Point Beach Nuclear Plant, Units 1 and 2
Dockets 50-266 and 50-301
License Nos. DPR-24 and DPR-27

License Amendment Request 245;
Technical Specification 3.3.4, Loss of Power Diesel Generator Start Instrumentation

LICENSE AMENDMENT REQUEST 245 TECHNICAL SPECIFICATION 3.3.4, LOSS OF POWER DIESEL GENERATOR START INSTRUMENTATION

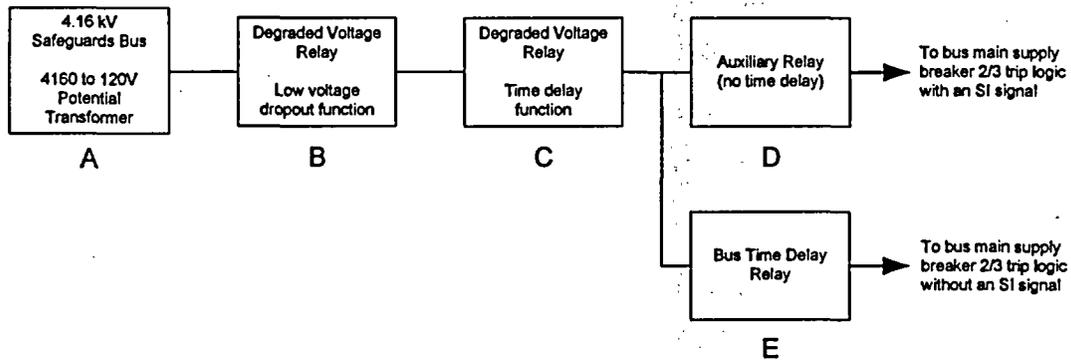
Degraded voltage protection on each 4.16 kV safeguards bus is provided by three degraded voltage channels, each with a degraded voltage relay having voltage and time delay settings and a bus time delay relay having a separate time delay setting. Each degraded voltage channel is configured as shown in the figure below:

Blocks A through D above provide degraded voltage protection coincident with an SI signal. When an SI signal is present and safeguards bus voltage remains below approximately 95% of nominal voltage as detected by a potential transformer (Block A), the degraded voltage relay (Block B) drops out and begins its time delay (Block C). After timeout, the degraded voltage relay output (through Block D) is combined with the other degraded voltage channels in a two-out-of-three coincidence logic to generate a bus main supply breaker trip. Opening the breaker disconnects the bus from offsite power, creating a loss of voltage condition on the bus. The bus loss of voltage function will then initiate DG start.

Blocks A, B, C, and E provide degraded voltage protection without an SI signal present. With no SI signal present and safeguards bus voltage sustained below approximately 95% of nominal voltage, the degraded voltage relay times out first, after which the bus time delay relay (Block E) times out. After timeout, the relay output is combined with the other degraded voltage channels in a two out of three coincidence logic to generate a bus main supply breaker trip. Opening the breaker disconnects the bus from offsite power, creating a loss of voltage condition on the bus. The bus loss of voltage function will then initiate DG start.

During both degraded voltage sequences above, if bus voltage should recover above the degraded voltage relay pickup setting prior to completion of the channel time delay, the degraded voltage relay resets and a channel trip does not occur.
